SYMBOL OF QUALITY AN ISO 9001 COMPANY		JINDAL ALUMINIUM LTD. BANGALORE-560073 (INDIA)		DRAWN	NAME	DATE
				CHECKED		
1. ALL DIMENSIONS ARE IN mm. 2. ROUND OFF ALL SHARP CORNERS WITH 0.40 mm. 3. TOLERANCES WILL BE AS PER IS:6477-1983 UNLESS OTHERWISE SPECIFIED		APPROVED	S.S.GARG	28-02-2013		
PARTY'S NAME SAHIB TRADING CO., MOHALI		SCALE	1:1			
PARTY'S DRAWING No. AS PER DRAWING		AREA	mm ² 1072.523			
ALLOY & TEMPER 6063 T6		PERIMETER	mm. 440.542			
DESCRIPTION HEATING PLATEN SECTION		WEIGHT	kg/m 2.896			
		DRAWING No.	SECTION No.			
P-10983		-				
S2939		S2939-ISSUE-3				
28028		28028

MATCHING SECTION
SCALE 3:1

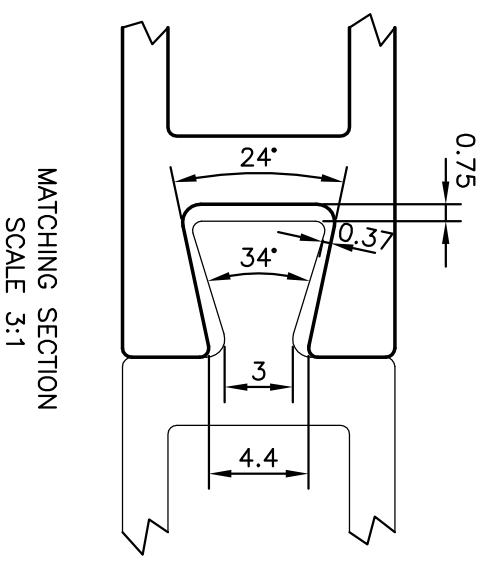
ISSUE (2) :-
DIMENSION CHANGED FROM :-
64.00 TO 63.35
6.00 TO 6.75 AND
ANGLE ALSO CHANGED FROM
28° TO 24° & 34° & WEIGHT ALSO
CHANGED FROM 2.418 kg/M TO 2.426 kg/M

ISSUE (3) :-
DIMENSION CHANGED FROM:-
1. 63.90 mm. TO 62.40 mm.
2. 63.35 mm. TO 61.85 mm.
3. THICKNESS 2.0 mm. TO 3.5 mm. (4 PLACES).
4. WEIGHT ALSO CHANGED FROM 2.426 kg/m. TO 2.896 kg/m.
